**DEPARTMENT OF PUBLIC WORKS
MADISON, WISCONSIN**

Contract Name CCB/MMB Tenant Improvement
Remodels - Phase 2

Date	5/9/2008
Change Order Number	CO 7
To Public Works Contract Number	6080
Original Contract Project Number	0
Change Order Project Number	0

Change Order Description Miscellaneous change requests

MMB 2ND FLOOR

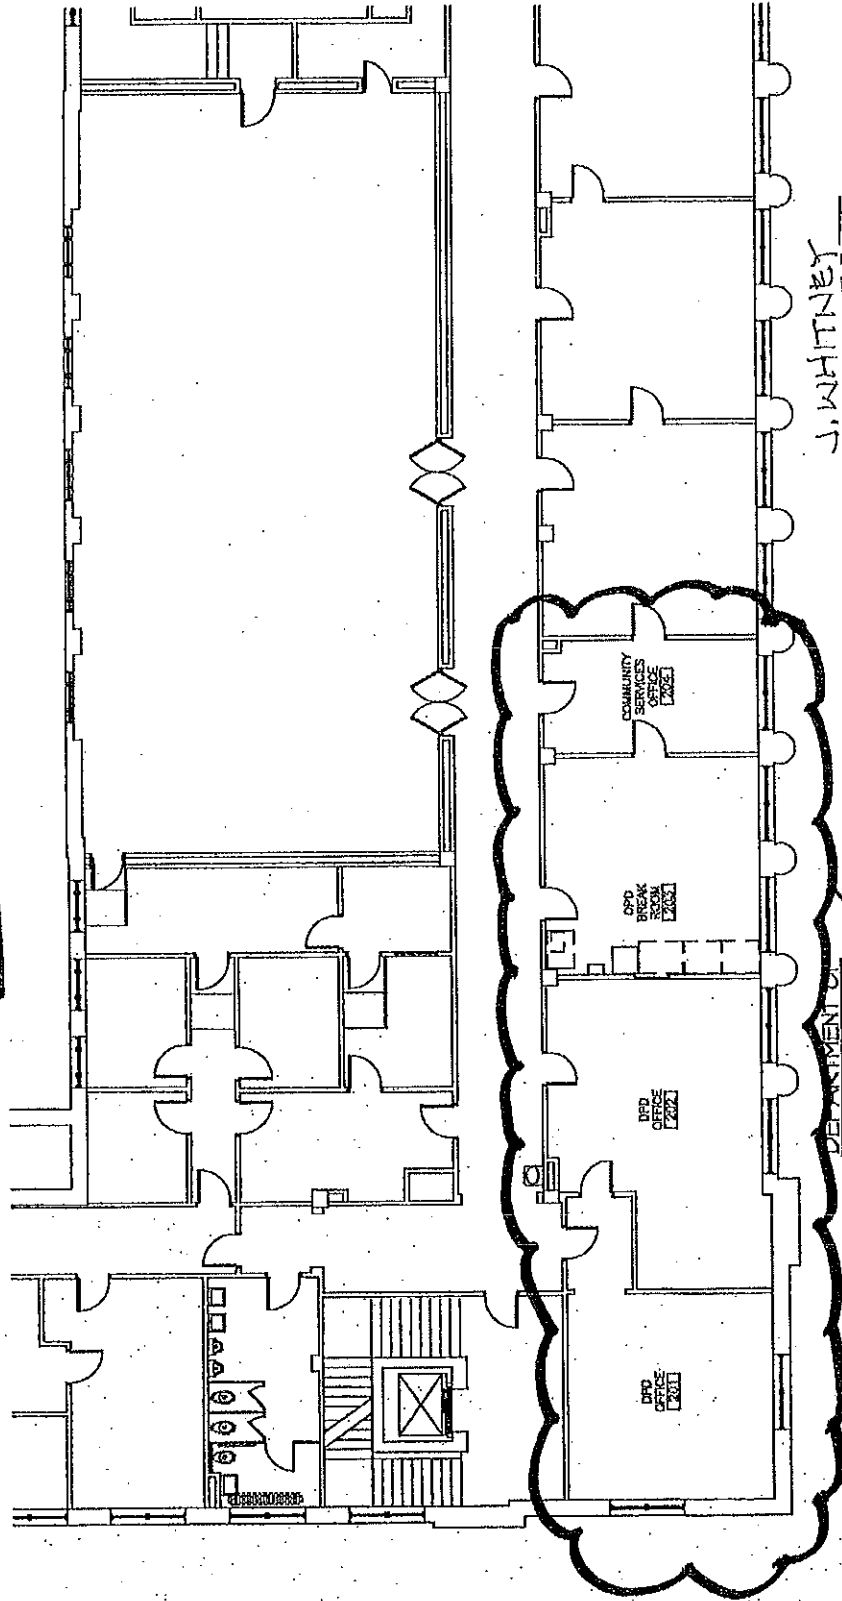
Attached copy of .pdf for 2nd floor area that needs to be deleted from the project. Jim

Hold on work
in this area

MMB: Delete all work on 2nd floor area at MMB.
Includes requested backup from Subcontractors.

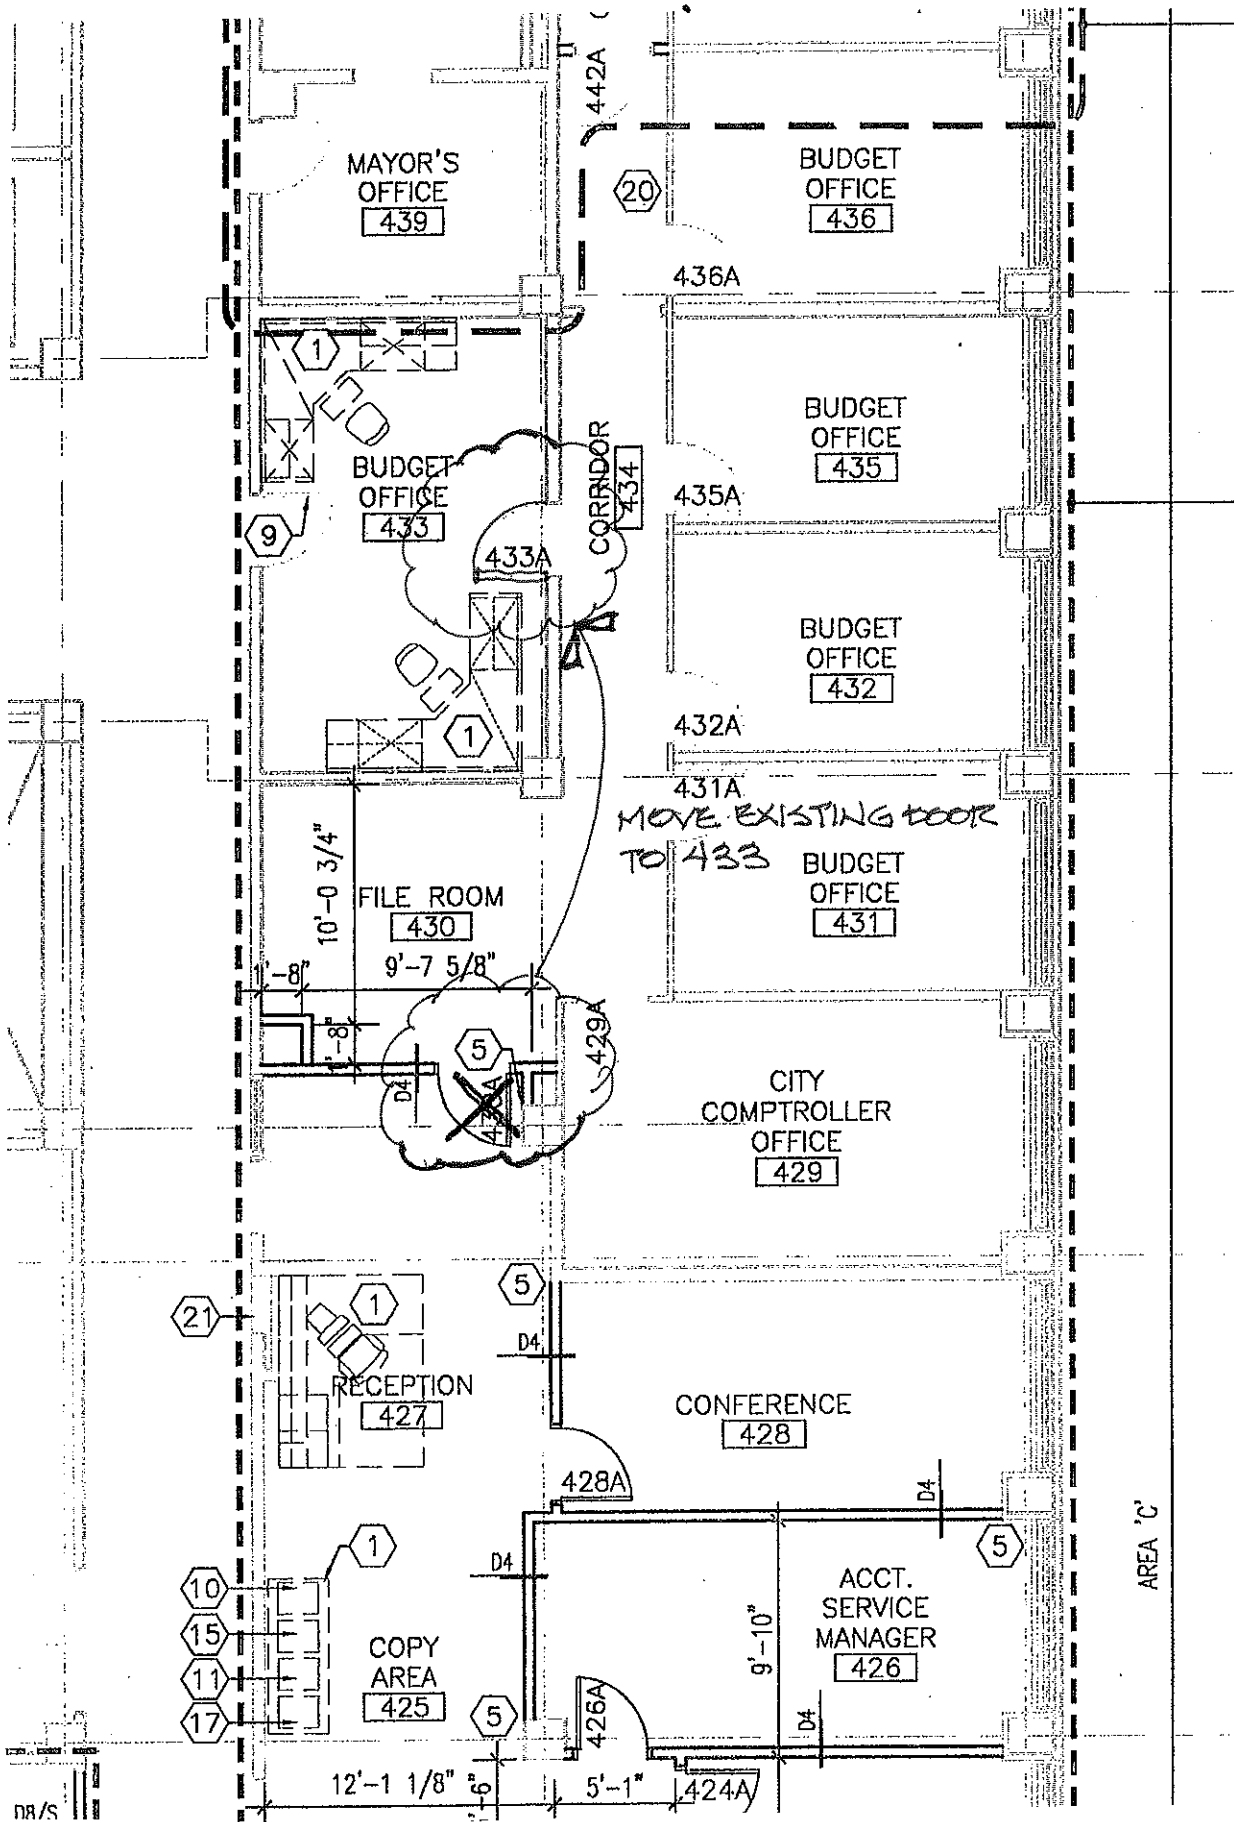
CCB: Relocate Door 430A to Frame 433A. Provide blanks at Frame 430A.
Provide new strike plate at Frame 433A.

Block Need 1 Strike
3) Hing + Blank & 1) Strike Blank
 TRICITY (Strike Kit - 2 - 1 for top & 1 for the bottom - #20)

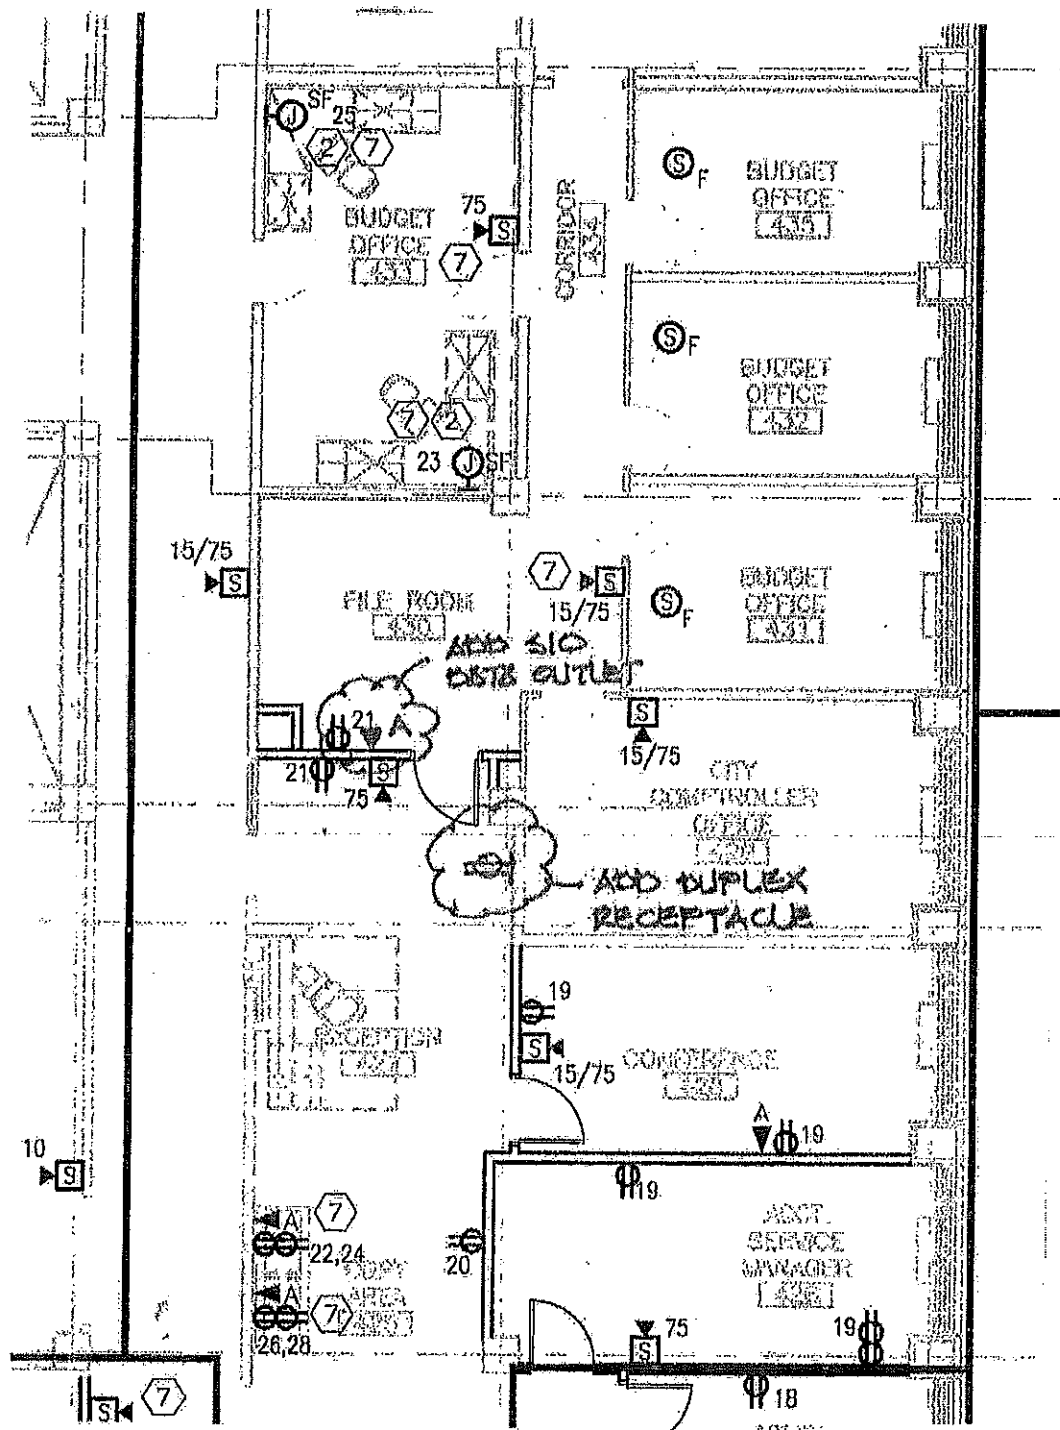
We've thought a little further about locating the bottled water and have decided that the reception area would not be the best place for it. That said, you can cancel the request for the receptacle in Room 427.

- 1) add one door in Comptroller Office 429 and one door in Work Room 418.
- 2) add one SIO data outlet in File Room 430 and one duplex receptacle in Reception 427.

See attached mark-ups.

CCB: Add one SIO data outlet in File Room 430 and one duplex receptacle in Reception 427.

I want to keep the power receptacle added on the wall in 427 for future use and housekeeping use if needed.

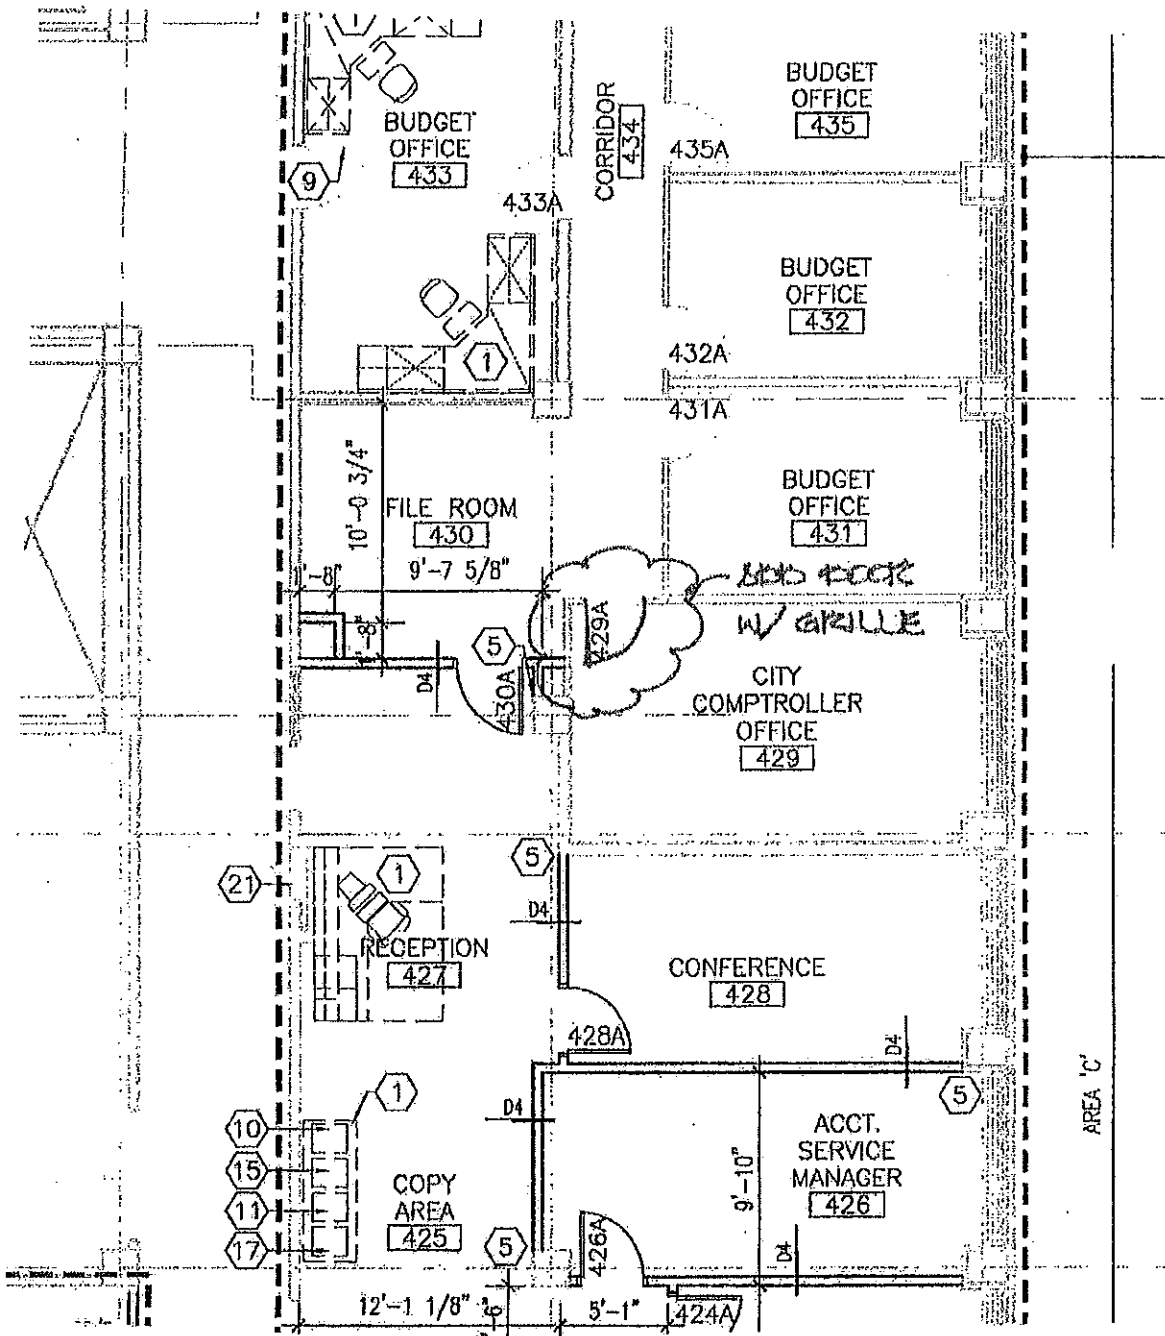
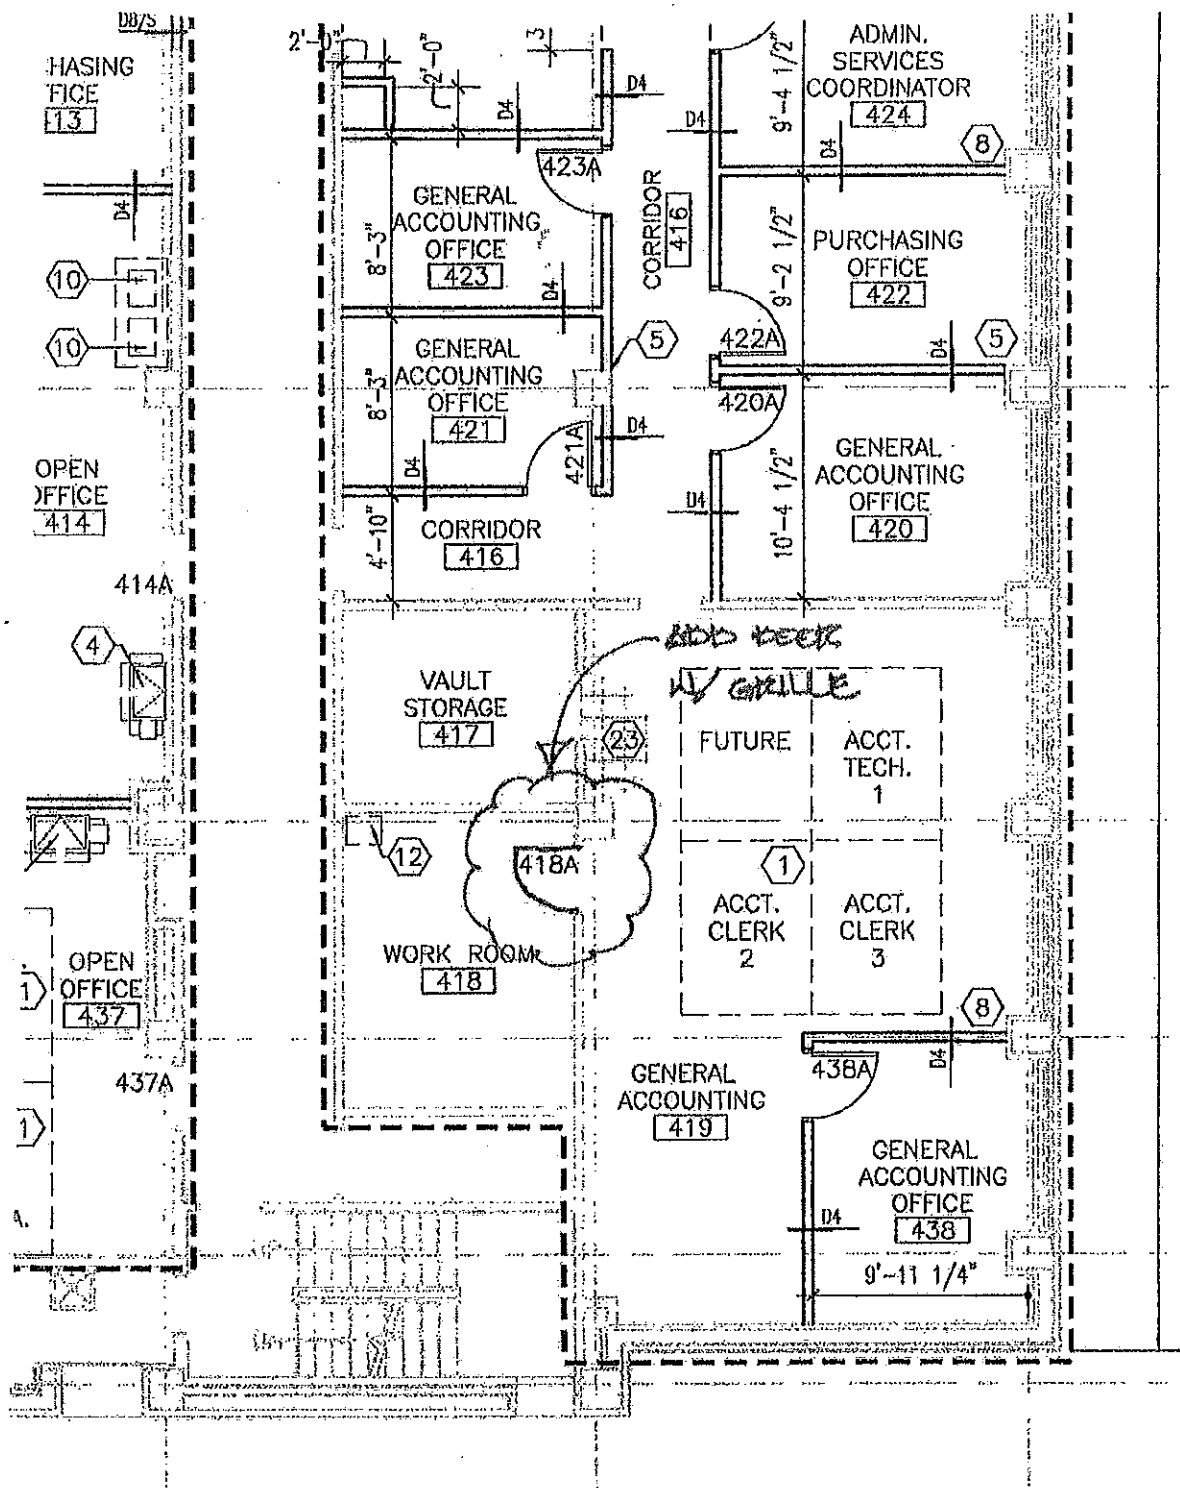
CCB: Add (1) door in Comptroller's Office 429 and (1) door in Work Room 418. Add (1) lock for Door 418A.

CCB PH 2 add doors outlets comptroller / Paul's 4/9/08 e-mail	Add (2) wood doors @ 429A & 418A, Add office function lock @ 418A <i>Note: 429A priced same as 420A and 418A prices same as 406A, because a door scheduled was not provided to determine the door size needed.</i>	\$1,251.00	07-1582RS.15
Total		\$1,251.00
